PLANNING & ZONING CASE NO. SP2025-033

PROJECT NUMBER: SP2025-033
PROJECT NAME: Site Plan for 102 West Bourn Street
SITE ADDRESS/LOCATIONS: 102 West Bourn Street, Rockwall, TX, 75087

CASE CAPTION: Discuss and consider a request by Dub Doupbrate of Doupbrate & Associates, Inc. on behalf of Kim Timpa for the approval of a Site Plan for an Office Building on a 1.1308-acre parcel of land identified as Lot 1, Block B, Jack Canup Addition, City of Rockwall, Rockwall County, Texas, zoned Planned Development District 62 (PD-62) for General Retail (GR) District land uses, addressed as 906 S. Goliad Street [SH-205], and take any action necessary.

TO: Planning and Zoning Commission
DATE: September 30, 2025
APPLICANT: Dub Douphrate; *Douphrate and Associates*
CASE NUMBER: SP2025-033; *Site Plan for Timpa Law Office*

FLOOR PLAN

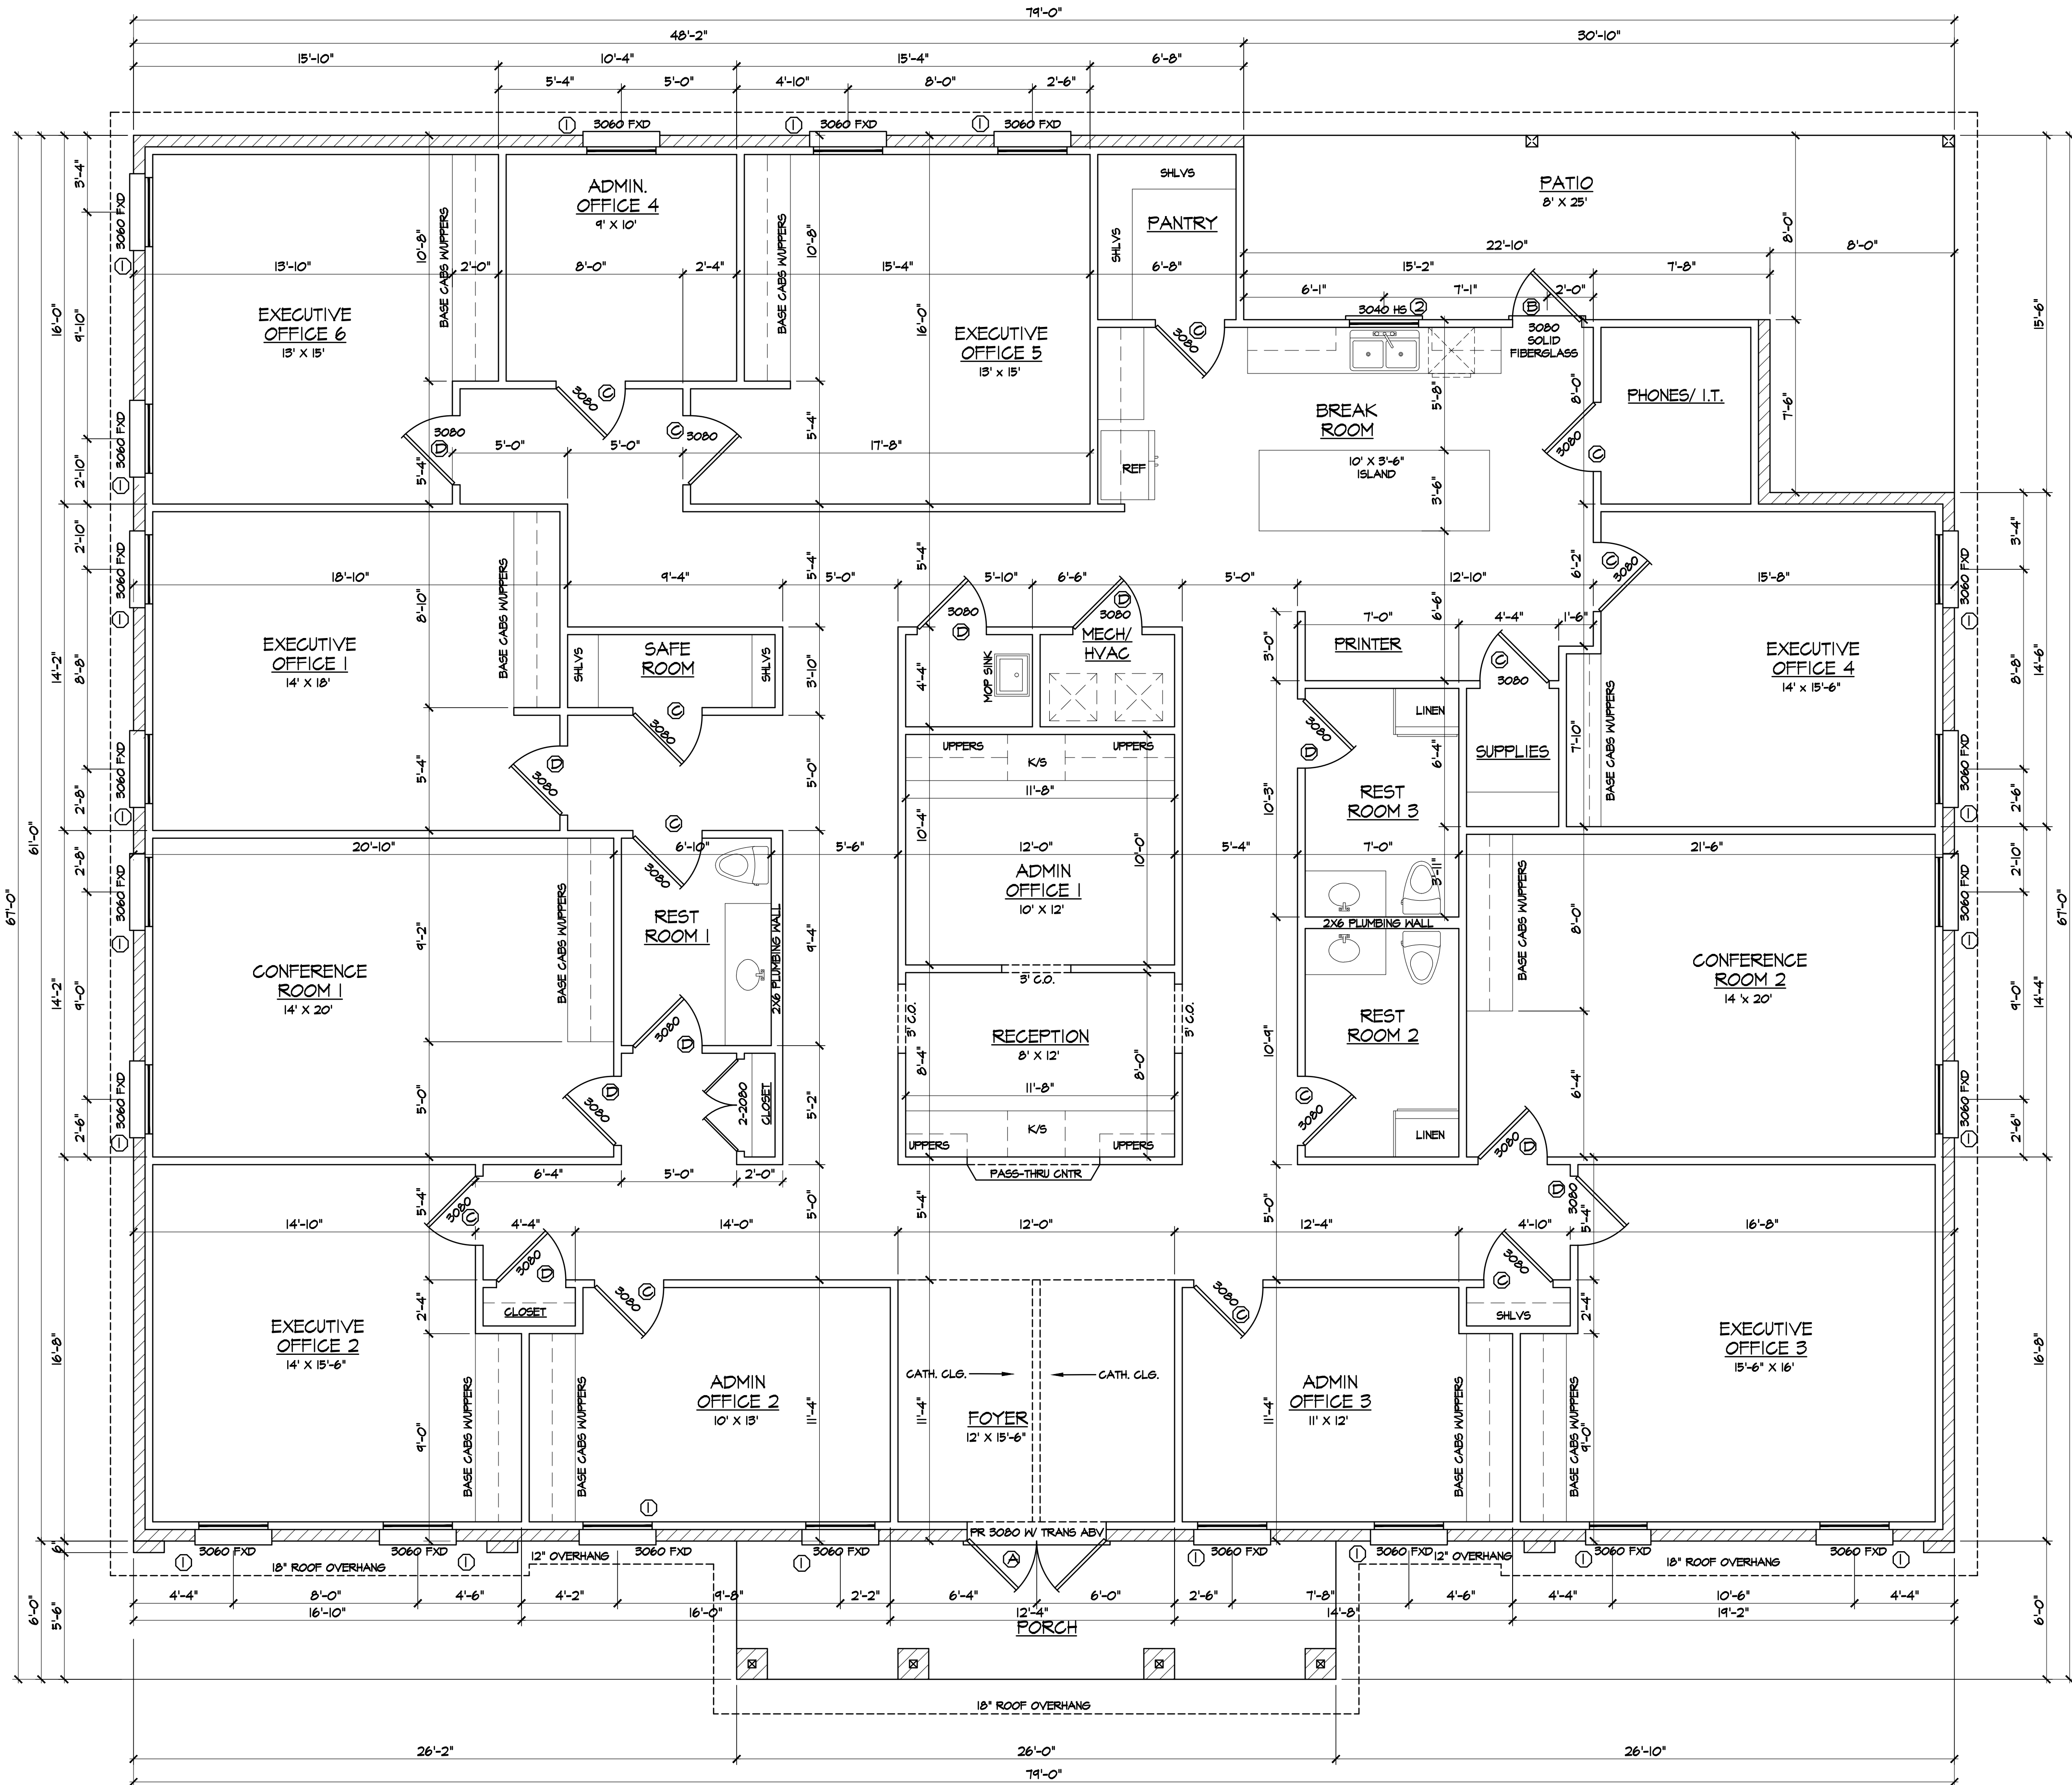
DEPARTMENT	REVIEWER	DATE OF REVIEW	STATUS OF PROJECT
BUILDING	Craig Foshee	08/21/2025	Approved
08/21/2025: DOES NOT APPROVE THE INTERIOR PLAN

SITE & LANDSCAPE PLAN
KIM TIMPA LAW OFFICES
906 S GOLIAD @ BOURN TX
CITY OF ROCKWALL,
ROCKWALL COUNTY, TEXAS

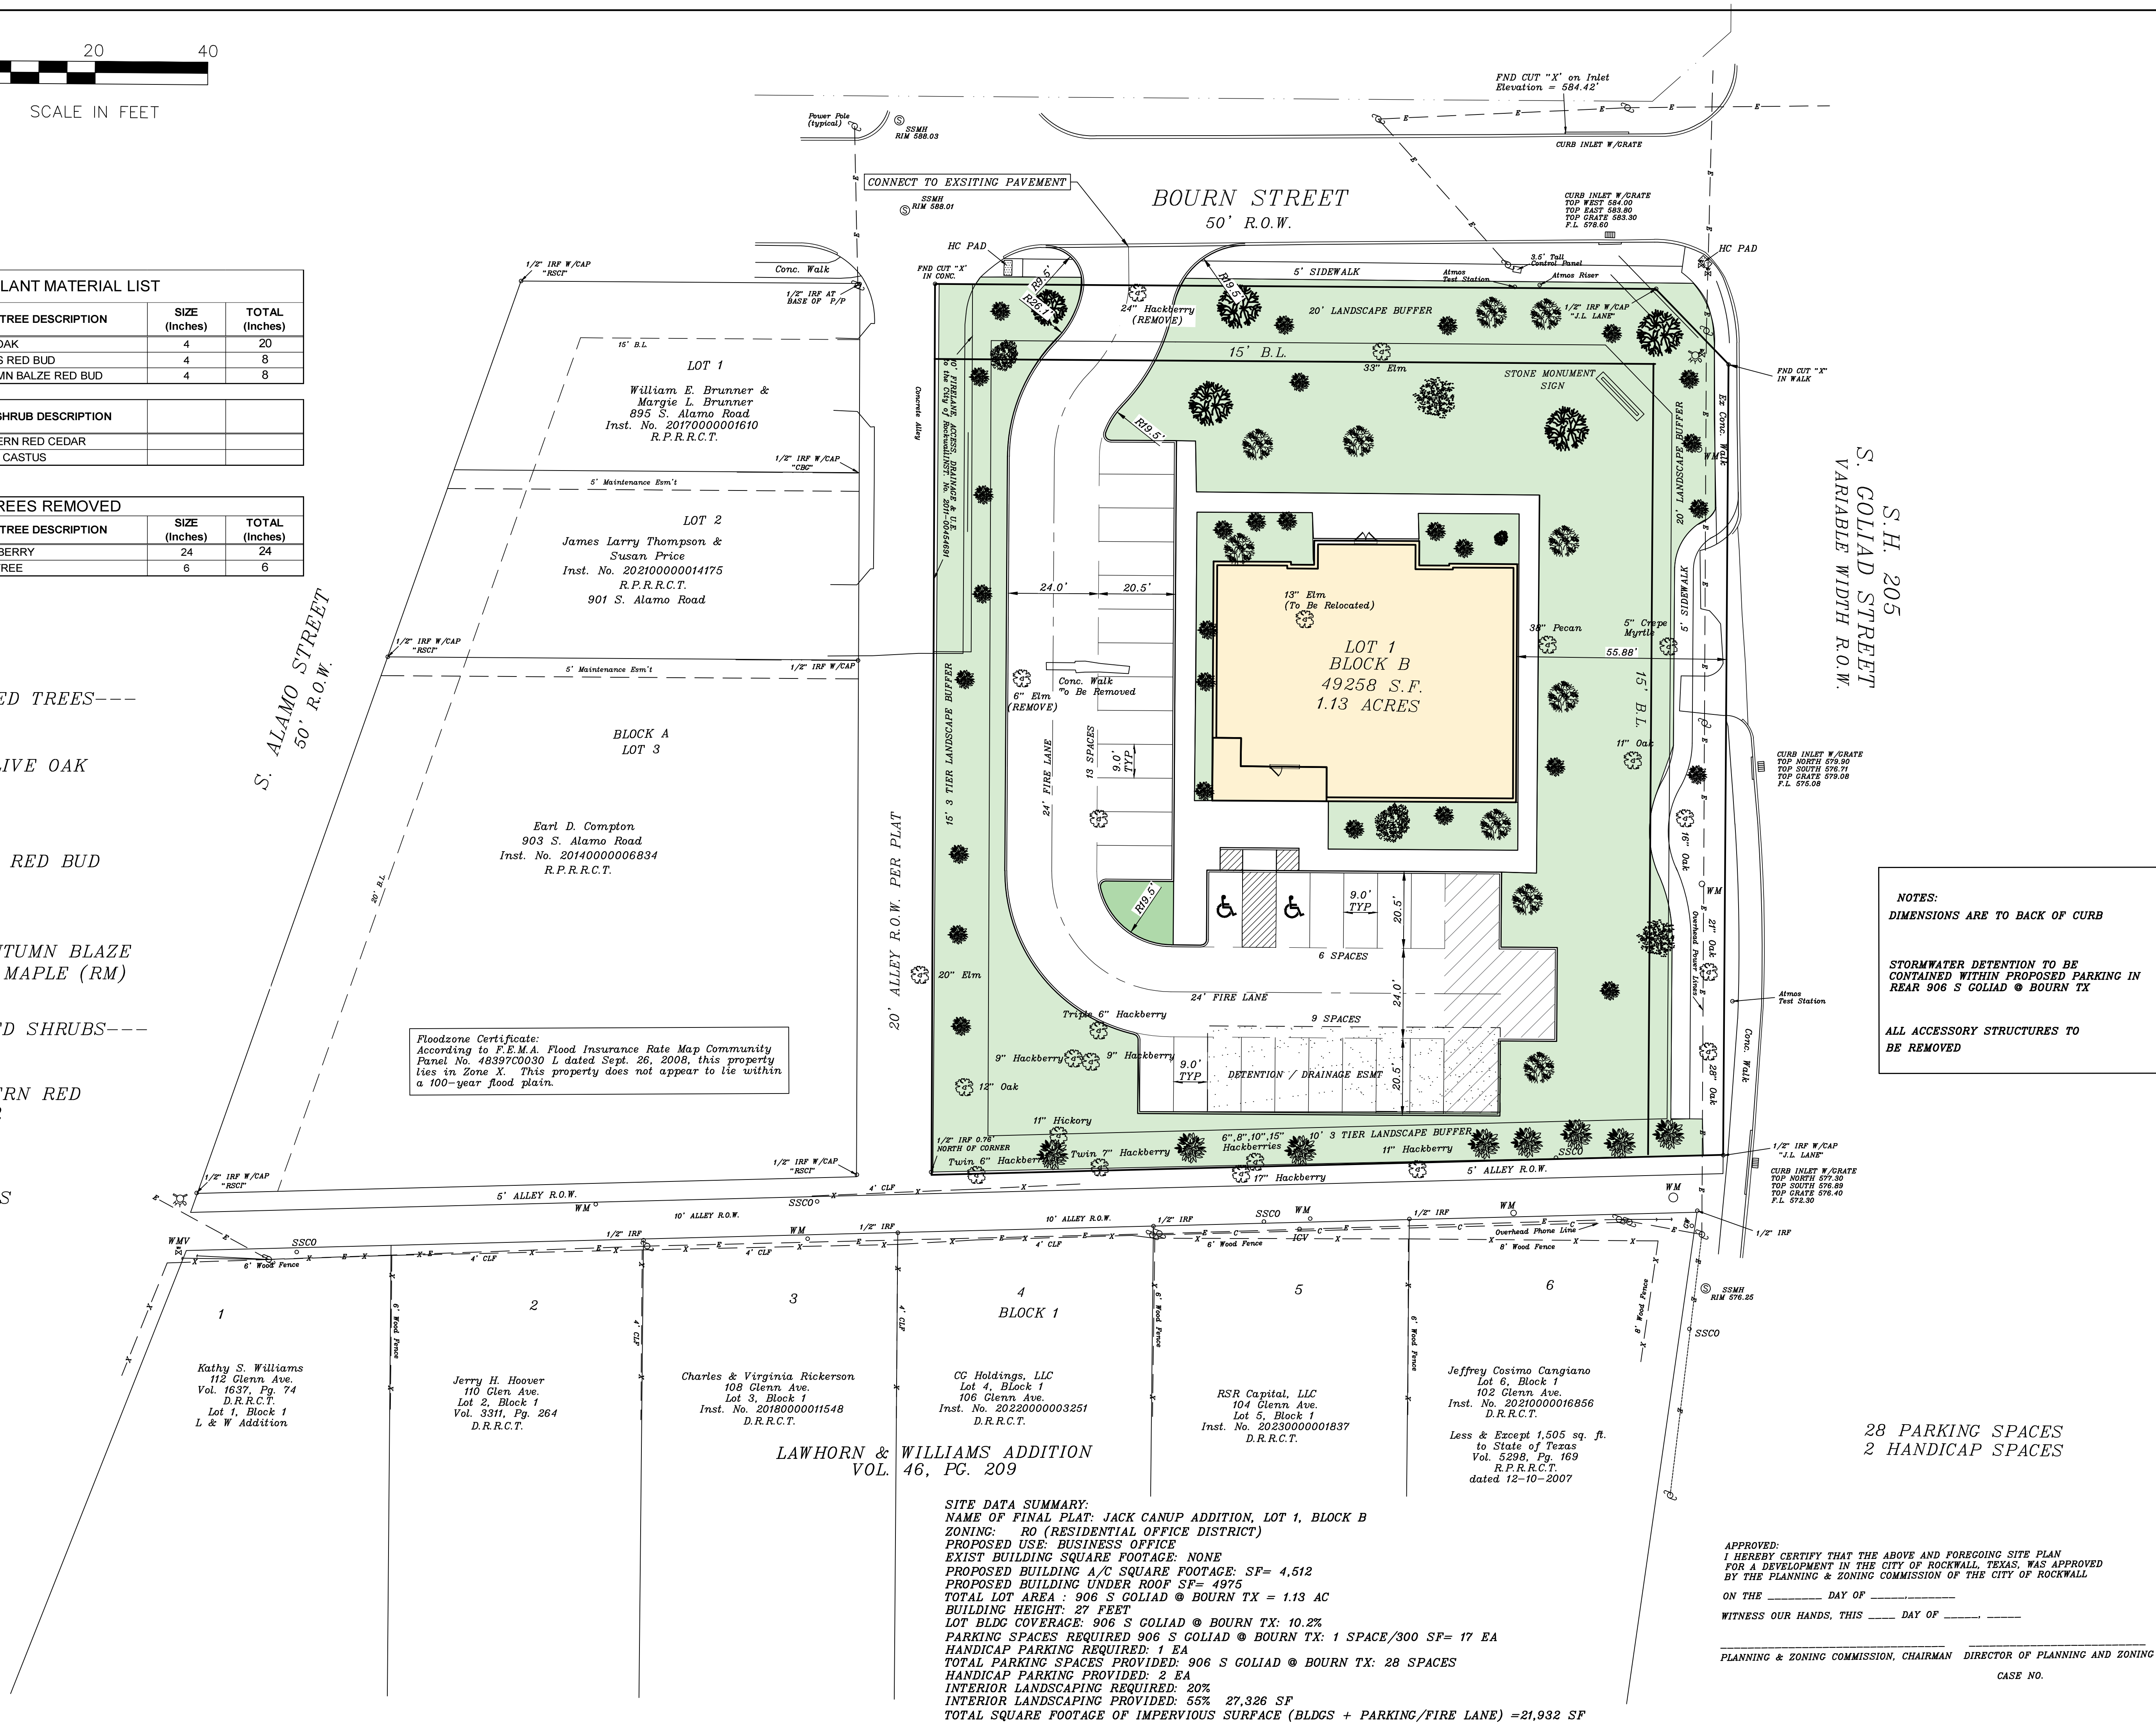
M.5 Site Plan/Landscape Plan

- (1) Separate the Landscape Plan and Site Plan into two (2) separate documents.
- (2) Pad mounted utility equipment, and air conditioning units, shall be screened from horizontal view from any adjacent public street and from any adjacent property. Utility equipment and air conditioning units shall be screened utilizing plantings berms, or walls matching the main structure. (Subsection 01.05.C, Article 05, of the UDC) Please indicate on your site plan if there are any pad mounted utility equipment. Utility equipment will be subject to screening if found later at engineering or building permit.

- (3) Provide the square footage of the proposed building on the site plan. (Subsection 03.04.B, Article 11, UDC)
- (4) Provide the perimeter dimensions of the building. (Subsection 03.04.B, Article 11, UDC)

- (5) Indicate all drive/turning radii. (Subsection 03.04.B, Article 11, UDC)
- (6) Provide adjacent street centerlines for Bourne Street and S. Goliad. (Subsection 03.04.B, Article 11, UDC)

- (7) Provide median breaks in adjacent streets [S. Goliad]. (Subsection 03.04.B, Article 11, UDC)
- (8) Provide the type and depth of paving material. (Subsection 03.02, Article 06, UDC)

- (9) All portions of the parking lot shall be behind the front façade of the building. (Planned Development District 62 [PD-62]; Ordinance No. 05-42)
- (10) Show existing driveways located off of S. Goliad as "to be removed".

(12) Please provide the required 20' residential adjacency landscape buffer with three-tiered screening along the west and south property lines. Three-tiered screening comprises of a berm, a row of canopy trees 20' on center, a row of accent trees, and a row of shrubs. The shrubs will need to screen the headlights of cars so plant that section accordingly. (Subsection 01.06, Article 06, UDC) The 10' and 15' residential adjacency buffer will require an exception from the Planning and Zoning Commission.

(15) Please provide a table showing the number, species, and caliper of trees being removed. (Table 2, Article 09, UDC)

(17) Provide a note indicating irrigation will meet the requirements of the UDC. (Subsection 05.04, Article 08, UDC)

- 08/22/2025: 1. Driveway spacing variance required.
2. Must remove driveways and replace sidewalk in these areas.
3. Approved deadened parking turn around is 15'x64' paved, striped no parking.
4. Fire lane exceeds maximum dead-end length without a fire lane turn around.

- Site plan must show existing/proposed utility lines (Water, Sewer, etc.)
- Any public water lines must be a minimum of 8", looped, and must be in a 20' wide easement. (Meet City of Rockwall Standards of Design and Construction)
- Only one "use" off a dead-end line (domestic, irrigation, fire sprinkler, fire hydrant, etc.)
- There is an existing 8" water main along W. Bourn St. and SH 205 available for use.
- Minimum public sewer is 8".
- All commercial sewer connections must be made by a proposed or existing manhole.
- There is an existing 8" sewer main on the other side of W. Bourn St. available for use.
- Water and sanitary sewer and storm sewer must be 10' apart.
- All public utilities must be centered in an easement. Min 20' utility easements.
- Any utility crossings under a roadway must be by dry bore and be steel encased. Open cutting is not allowed.

- No trees to be with 10' of any public water, sewer or storm line that is 10" in diameter or larger.
- No trees to be with 5' of any public water, sewer, or storm line that is less than 10".
- No landscape berms or tree plantings shall be located on top of City utilities or within easements.
